Application for Certificate of Appropriateness for Design Review
City of Gahanna, Ohio ■ Planning Commission
200 S. Hamilton Road, Gahanna, OH 43230 ■ Phone: (614) 342-4025 ■ Fax: (614) 342-4125

*Site Address 1600 Eastgate Pkwy.
*Parcel ID# 025-010847, 025-010849, 025-006924, *Zoning District OCT
*Design Review of: Site Plan ☒ Landscaping ☒ Building Design ☒ Signage ☐ Other ☐
*Special Information Regarding the Property and its Proposed Use: Pizzuti Training Center

Project Name: Pizzuti Training Facility

Project Name: Pizzuti Training Center FDP and DR

CITY OF GAHANNA, FRANKLIN COUNTY, OHIO
FOR
FINAL DEVELOPMENT PLAN
COLUMBIA GAS TRAINING FACILITY
BLATT PROPERTY

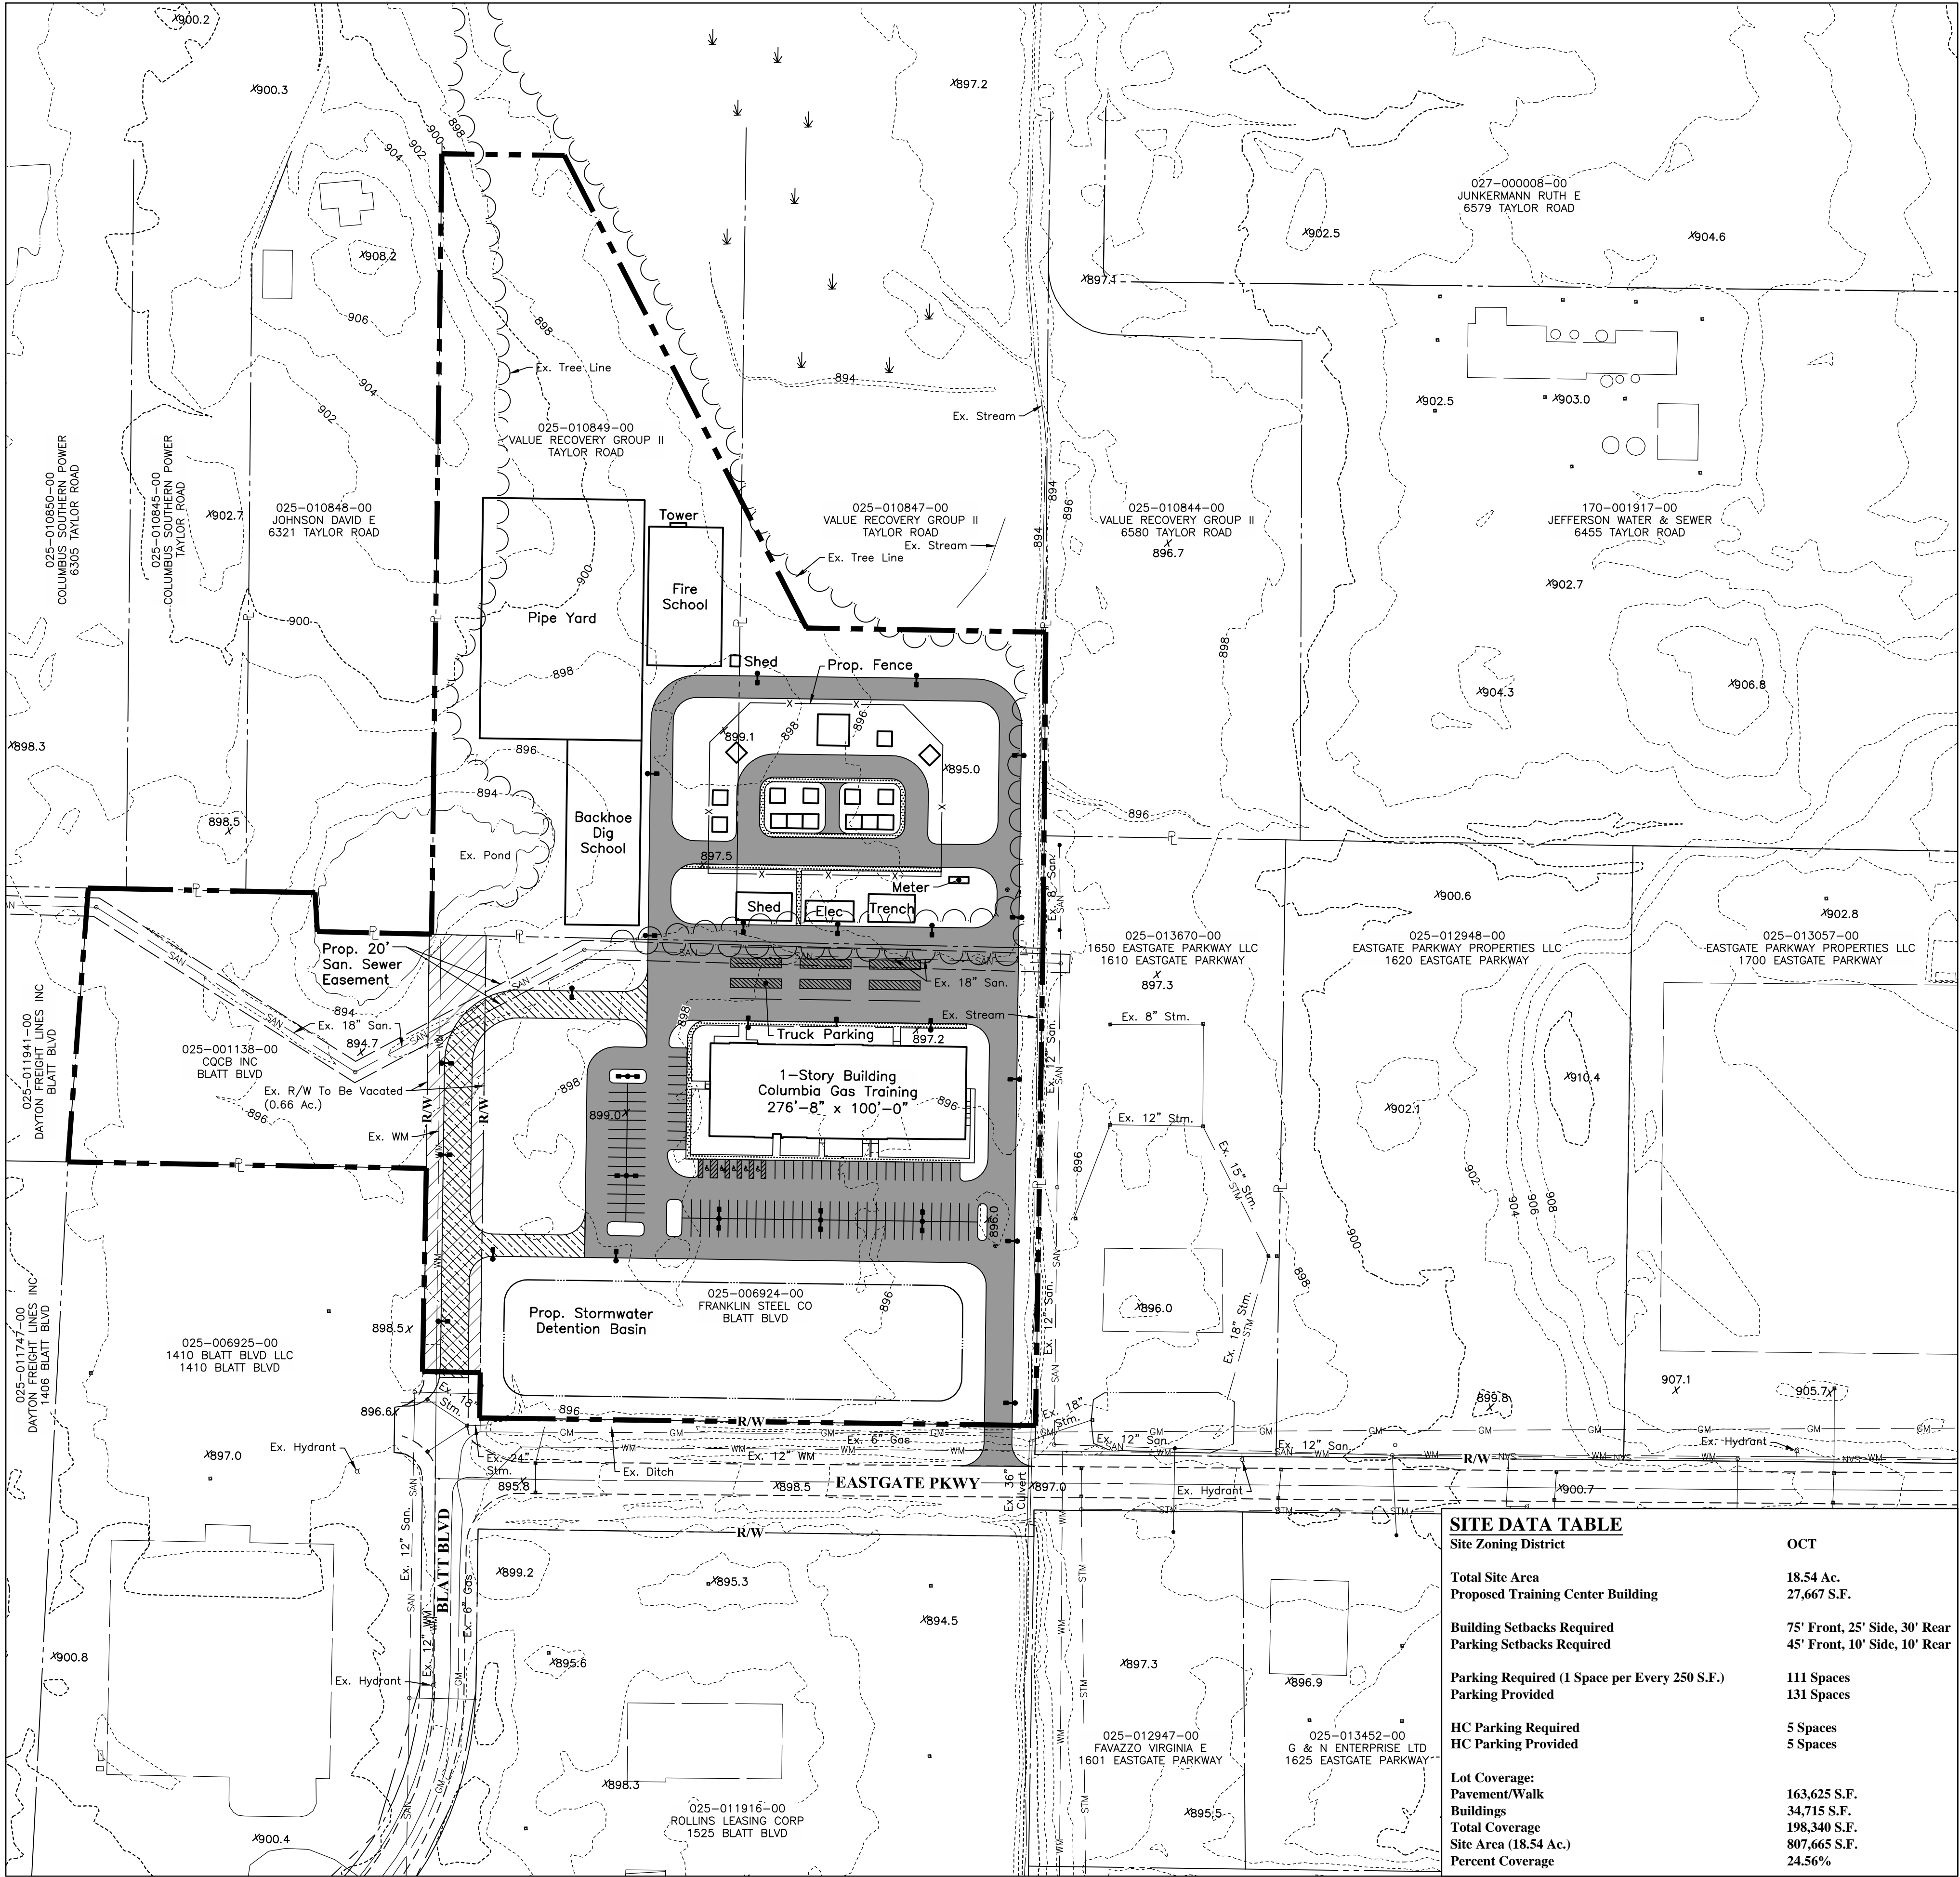
All applicable building and parking setbacks have been met. Right-of-Way will be purchased from the City to accommodate an access on the west side of the property from Blatt Blvd., and a second access to and from Eastgate Parkway will be provided on the east side of the property.

A subdivision without plat application is forthcoming and will be administratively approved to allow a piece of VRG's property (see site plan) to the north to be combined with the Pizzuti property to create the whole campus.

- Information provided by the developer shows that the development may generate more than 100 vehicle trips in the peak hour, or more than 1,000 total trips in a 24 hour period, thus a minor Traffic Impact Study will be required.
- Two access drives are shown for the project. It is suggested by our office that the easternmost access drive be coordinated with the adjacent property owner (Columbia Gas) for a potential shared access in an effort to reduce curb cuts on Eastgate.
- The western access may be built to private standards if the existing right-of-way is purchased by the developer or vacated. All existing utilities shall be provided easement if the right-of-way is sold or vacated. If the right-of-way remains, the roadway shall be extended per public standards.

- There is an existing 18 inch sanitary sewer located onsite that can be accessed to provide sanitary sewer service for the development. A sanitary sewer easement will be required to be dedicated to the City as part of the engineering plan review and approval process.

- There is an existing 12 inch water line located in an easement running along the north side of Eastgate Parkway. This line can be tapped to provide service to the development for both domestic and fire suppression.
- Jefferson Water and Sewer District should be contacted about the development since this site falls within their well protection zone.

- It appears storm water detention and water quality requirements will be addressed with

on-site per the provided site plan. Detention and water quality treatment design to be per City of Gahanna standards, Codified Ordinances Chapter 1193.

- We recommend that consideration be given to incorporating green infrastructure best management practices (BMP's) for detention and water quality measures.
- Erosion Control design and Post Construction Runoff Control to be per City of Gahanna (Chapter 1195) and Franklin Soil and Water Conservation District requirements.

CITY OF GAHANNA, FRANKLIN COUNTY, OHIO
FINAL DEVELOPMENT PLAN / LANDSCAPE PLAN
FOR
COLUMBIA GAS TRAINING FACILITY
BLATT PROPERTY

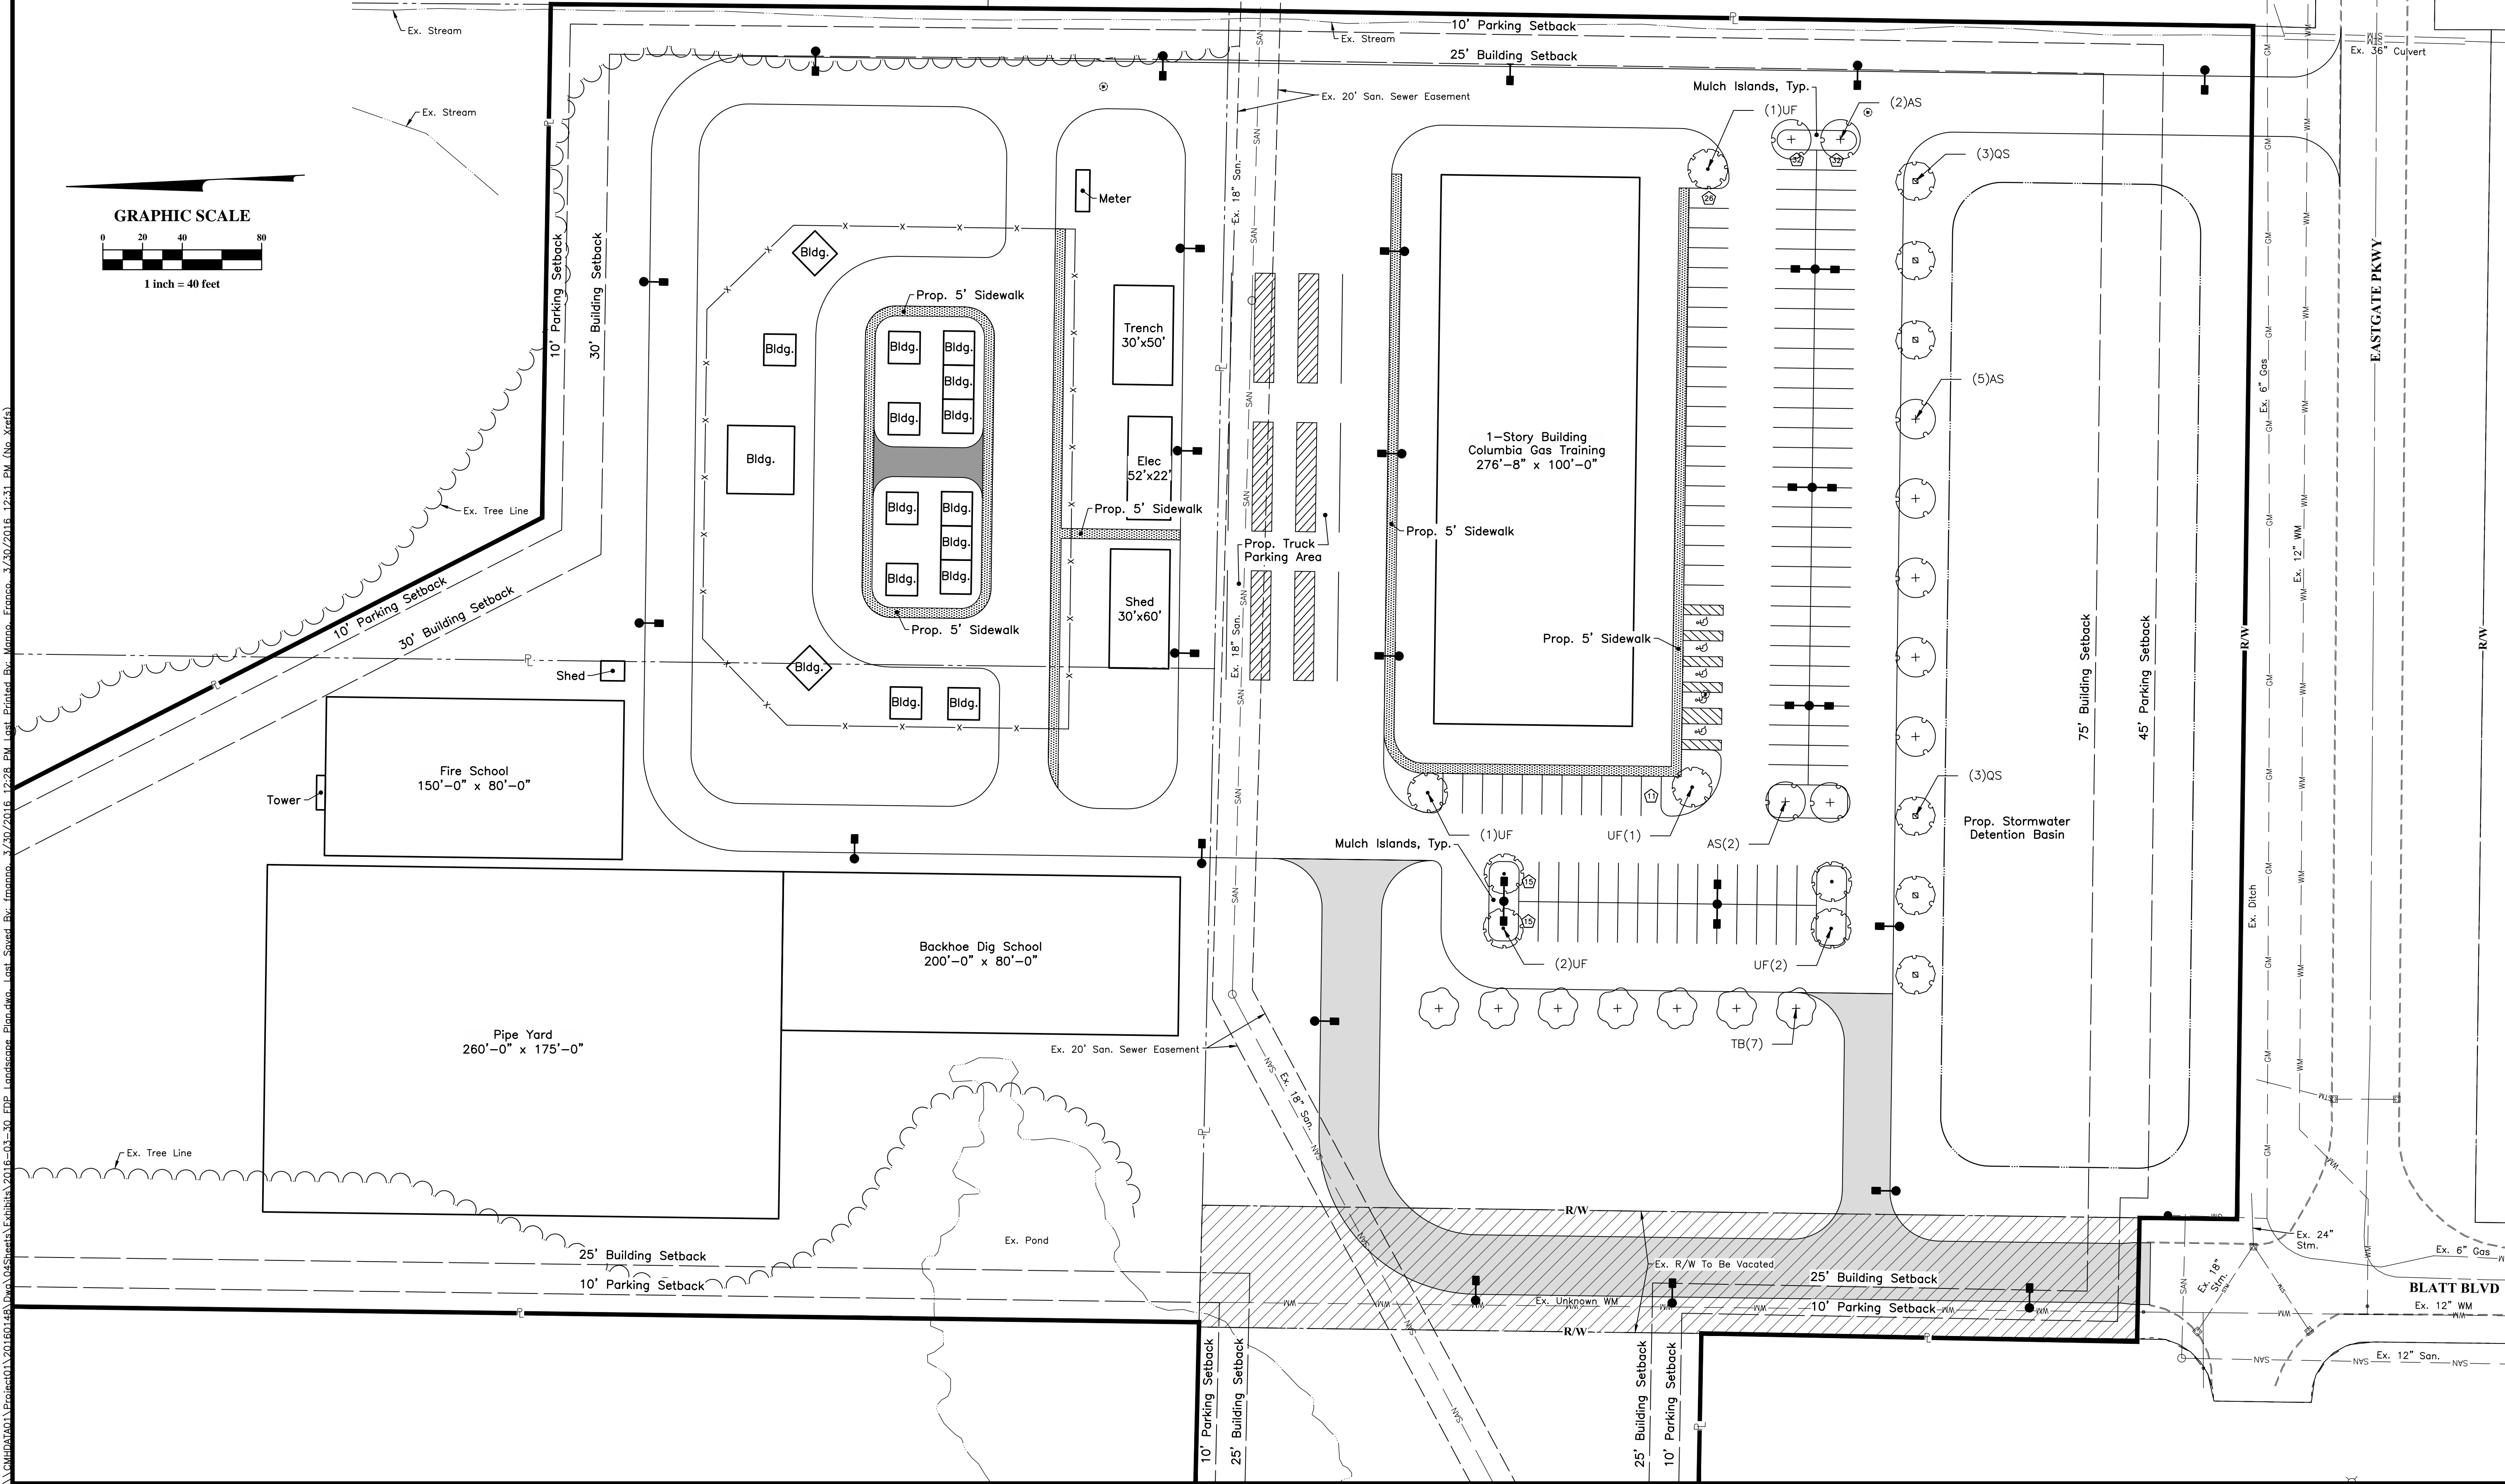
Exterior building materials are a mix of metal and synthetic stone, and will be compatible and comparable with the Columbia Gas building to the east. A photometrics plan and cut sheet for the lighting is included in the application. A total of 29 trees will be installed per code requirements.
